PERMIT ISSUED		Permit No: 01-0999	Issue Date: AUG 20 2001	CBL: 171 A006022
Location of Construction: 22 Wildwood Cir	Owner Name: Peck Robert R &	Owner Address: 22 Wildwood Cir		Phone: 207-772-3191
Business Name: n/a	Contractor Name: Commercial Property Maintenance	Contractor Address: PO Box 11302 Portland		Phone:
Lessee/Buyer's Name n/a	Phone: n/a	Permit Type: Alterations - Multi Family		Zone: R-5

Past Use: Condo Unit / Single Family	Proposed Use: Condo Unit / Single family; extend walk-in closet and add two skylights	Permit Fee:	Cost of Work: \$10,000.00	CEO District: 2
Proposed Project Description: Extend closet & add two skylights		FIRE DEPT: <input type="checkbox"/> Approved <input type="checkbox"/> Denied INSPECTION: <input type="checkbox"/> Approved <input type="checkbox"/> Denied Use Group: R-3 Type: 53 PERMIT ISSUED WITH REQUIREMENTS Signature: <i>[Signature]</i>		PEDESTRIAN ACTIVITIES DISTRICT (P.A.D.) Action: <input type="checkbox"/> Approved <input type="checkbox"/> Approved w/Conditions <input type="checkbox"/> Denied Signature: _____ Date: _____

BUILDING PERMIT REPORT

REASON FOR PERMIT: Extend Closet & add Two Skylights

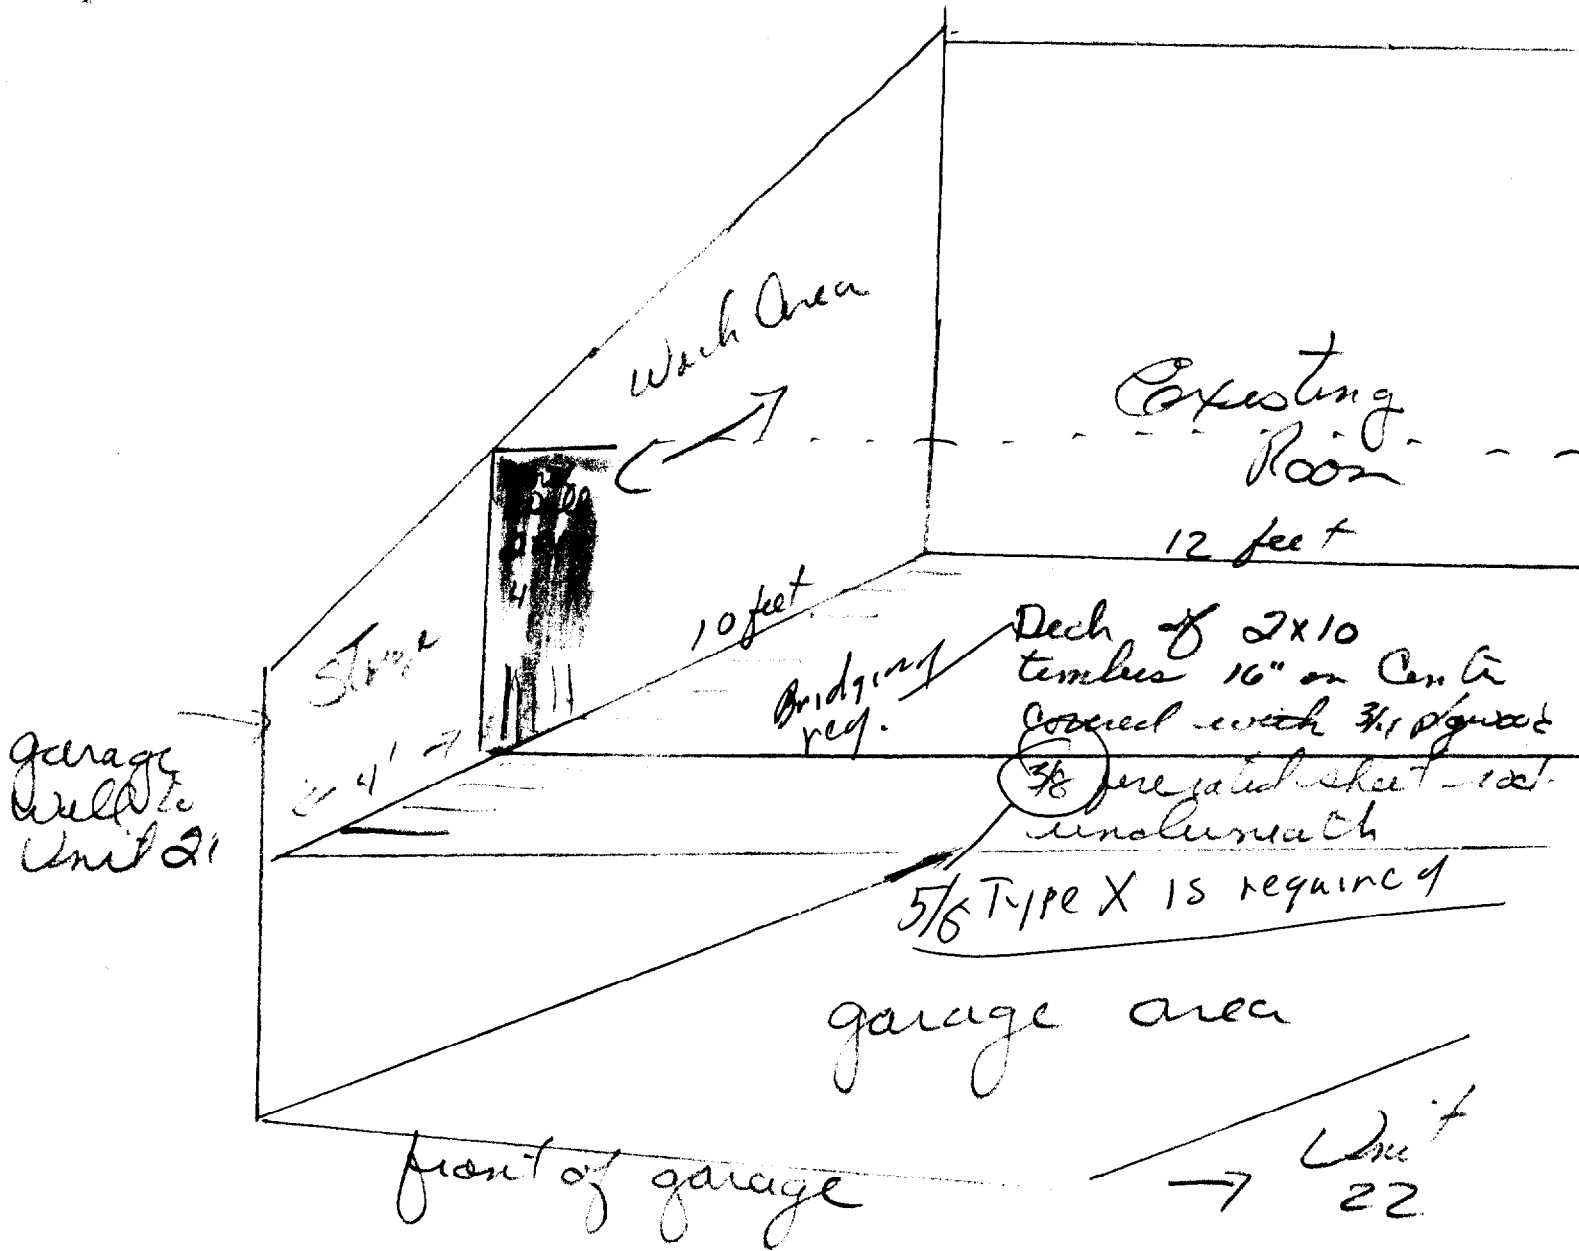
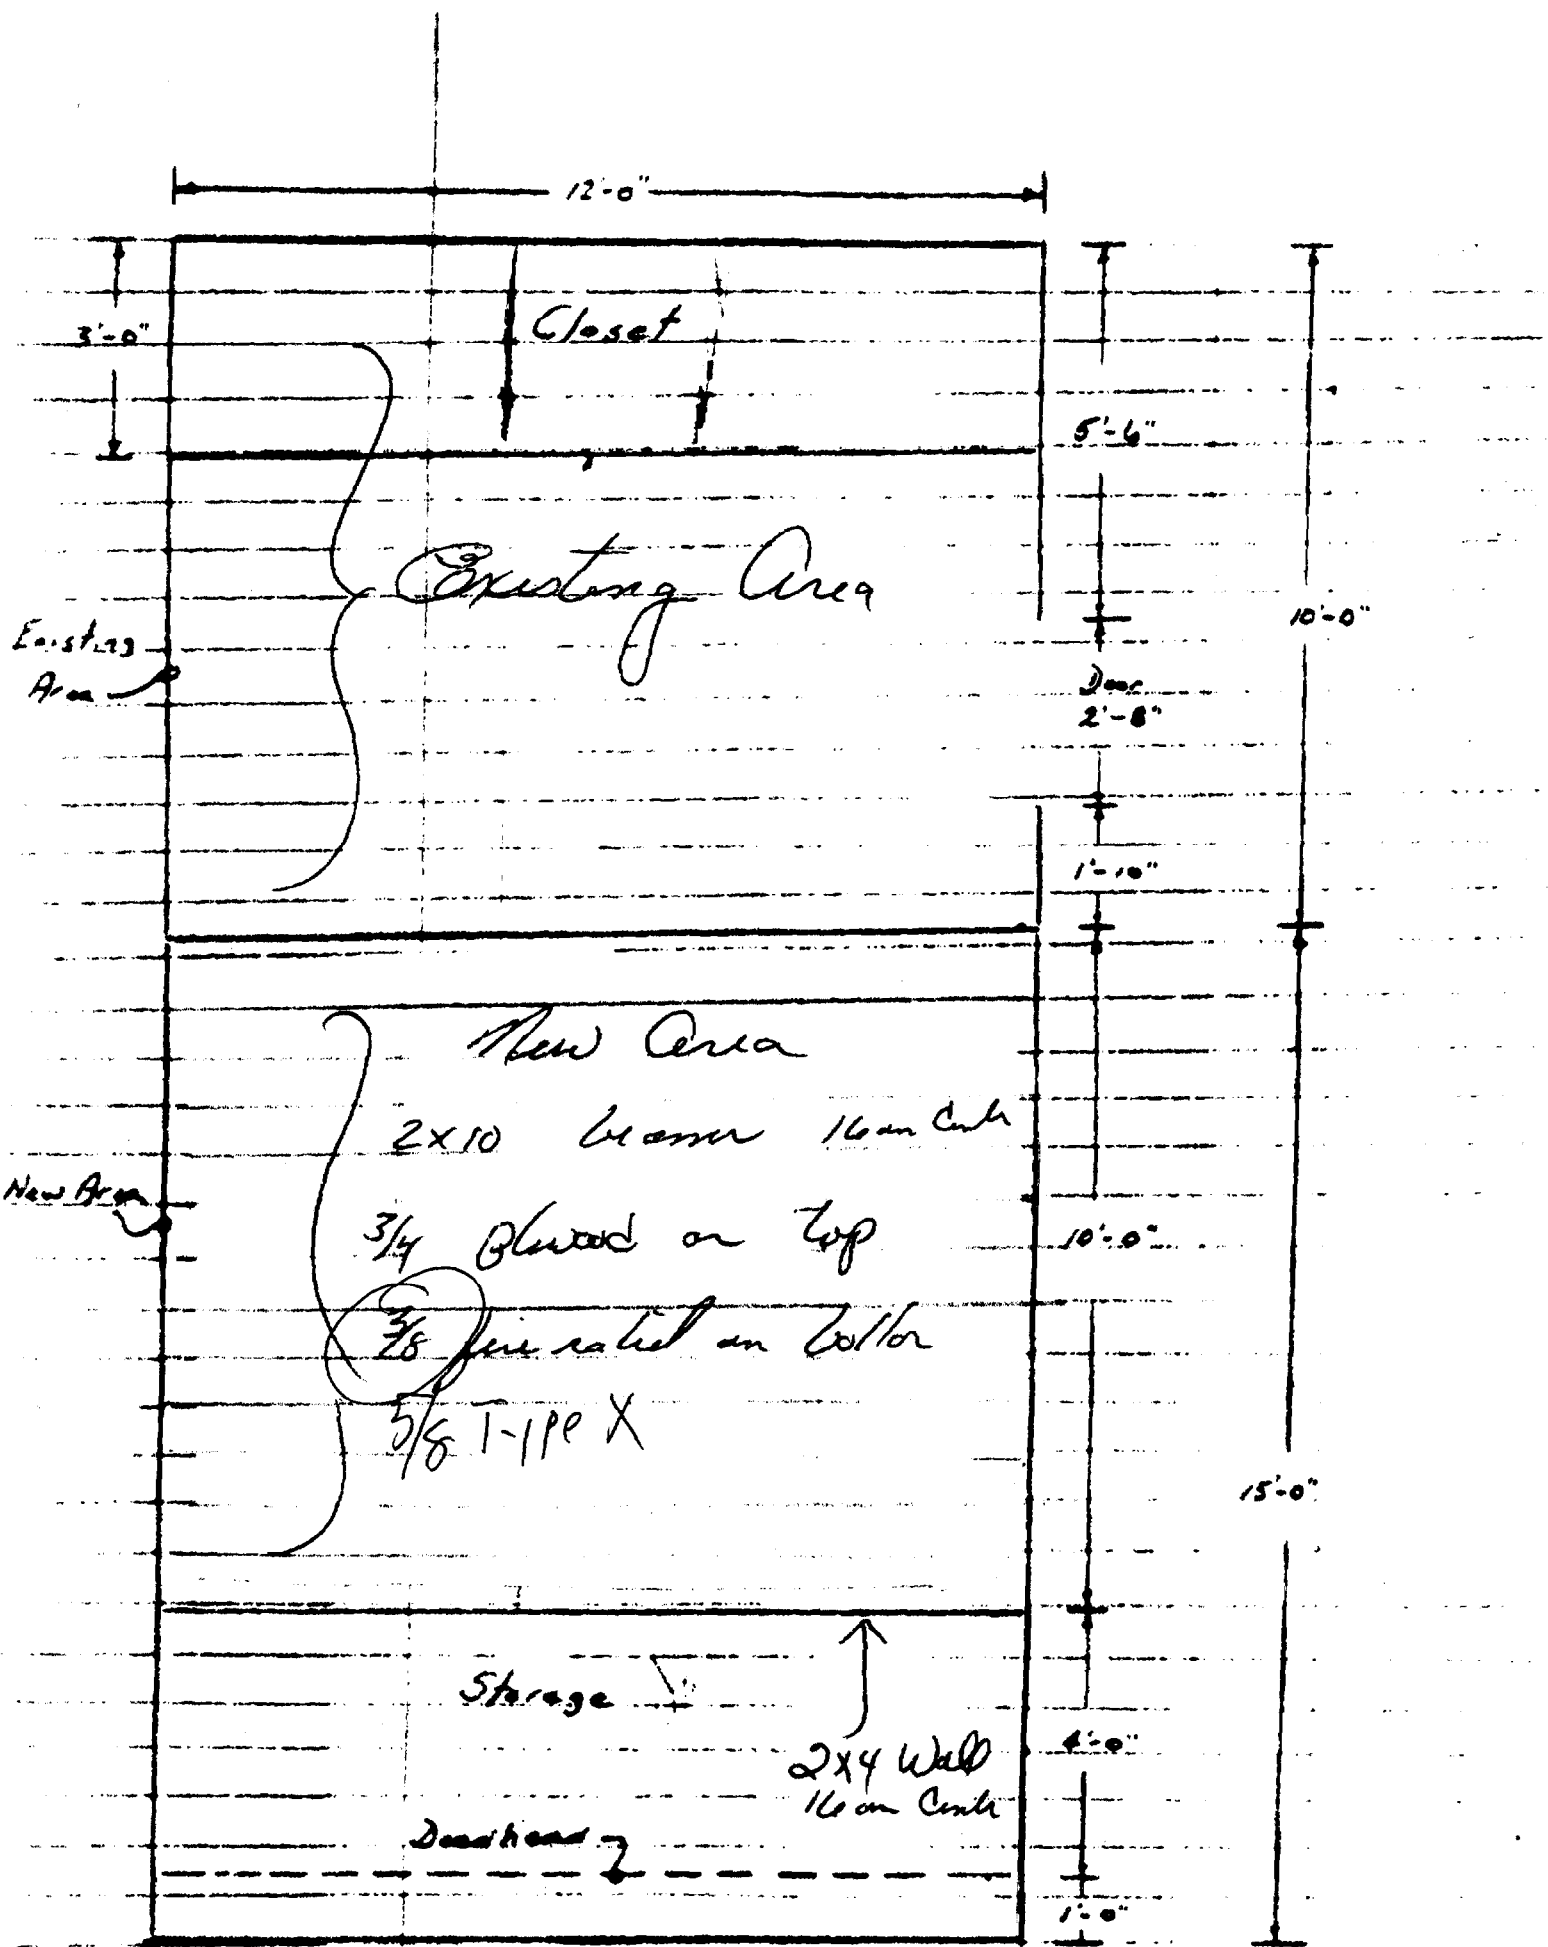
* 38. *Your letter dated (no date states 3/8" Fire rated sheet-rock - to my knowledge, there is no such rating on 3/8" / 5/8" Type X is required.*

*No such thing 5/8
5/8 Type X is rated*

5/8 T-1PE X

Placement of 2
new Sky light
(Roof Windows)

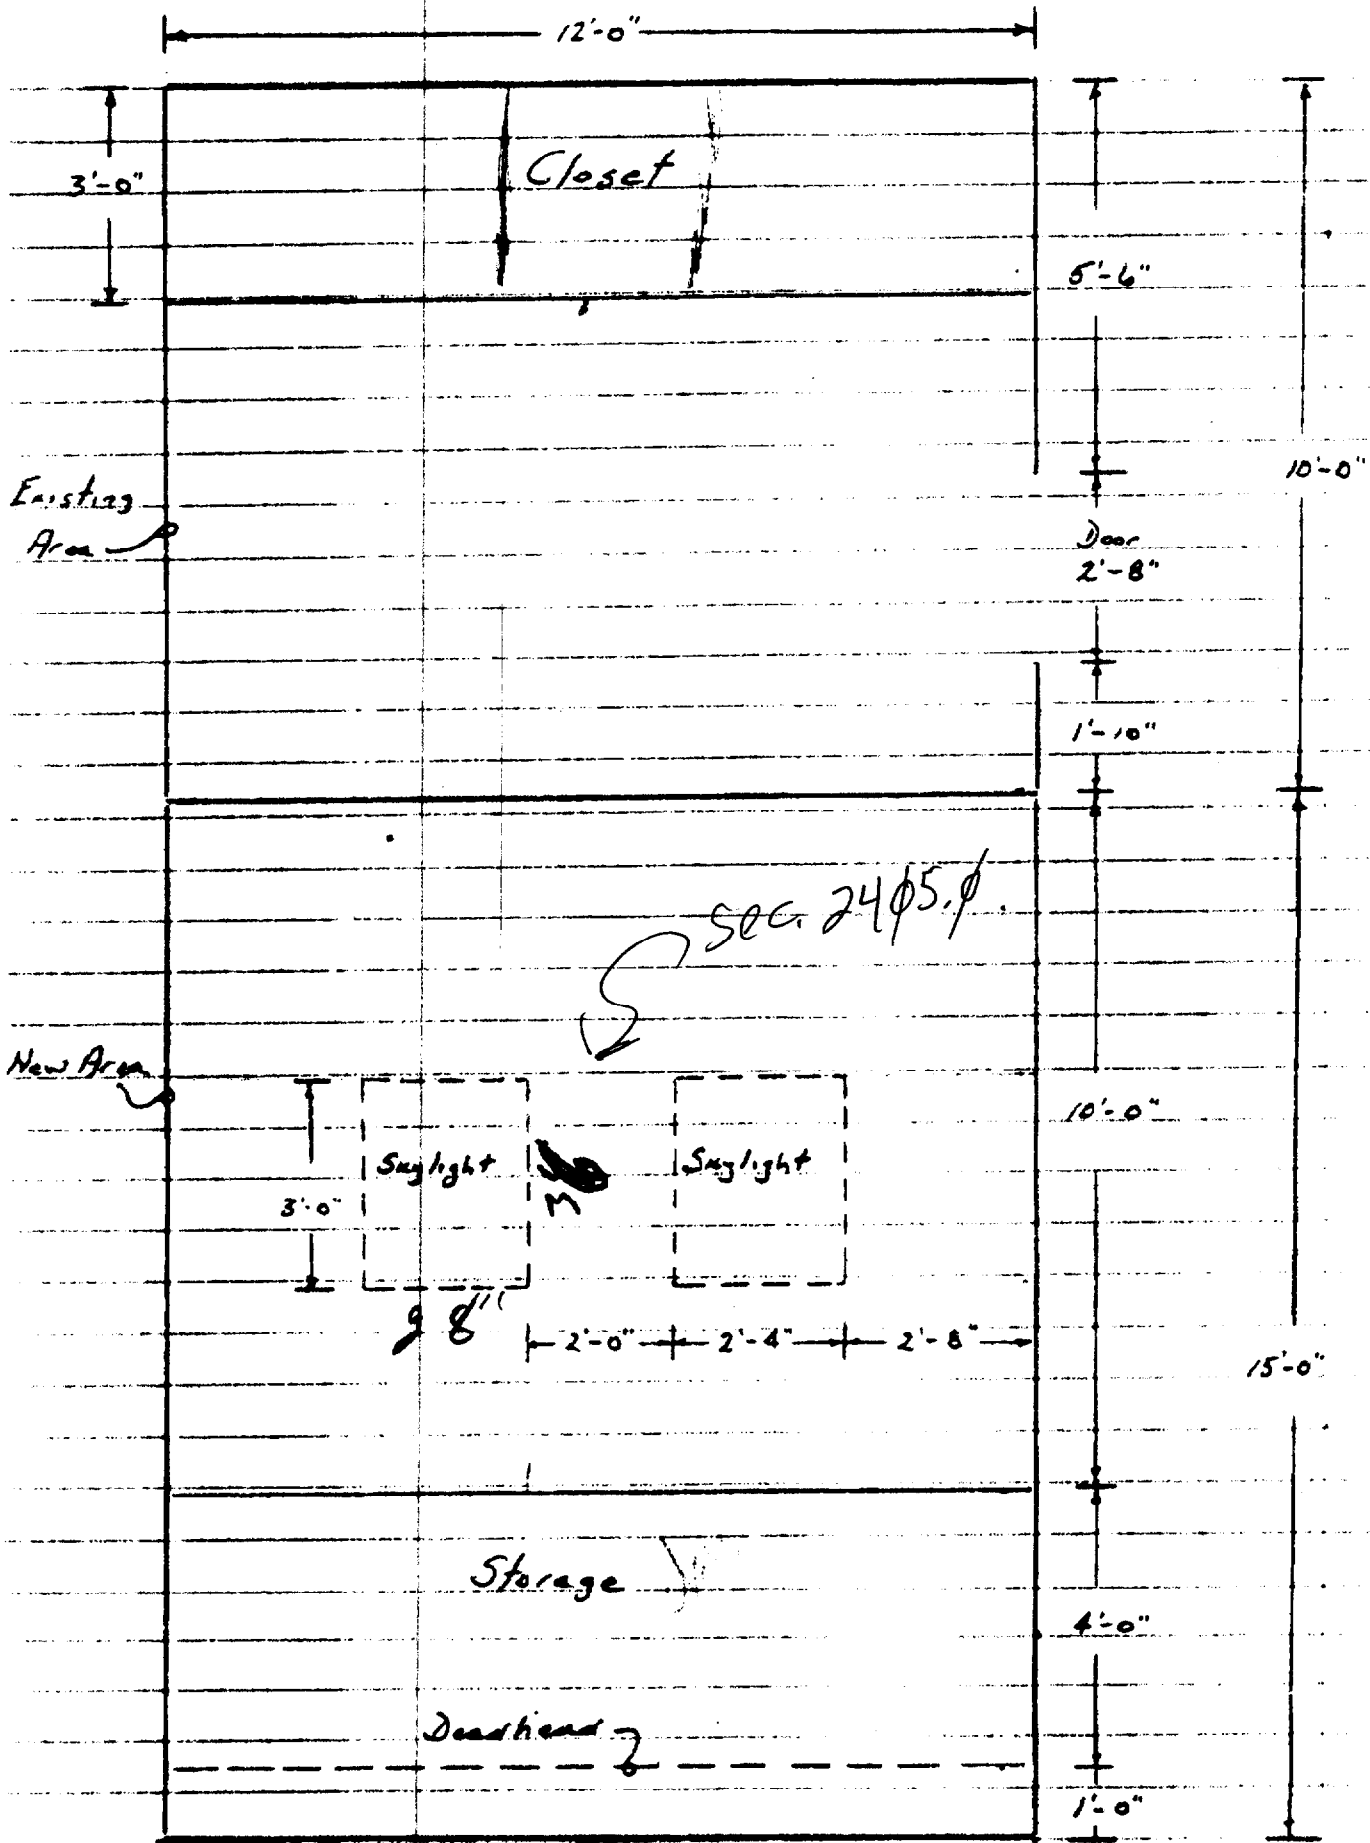
* 39. *Framing of new skylight shall require special framing - framing detail shall be submitted before work is started.*
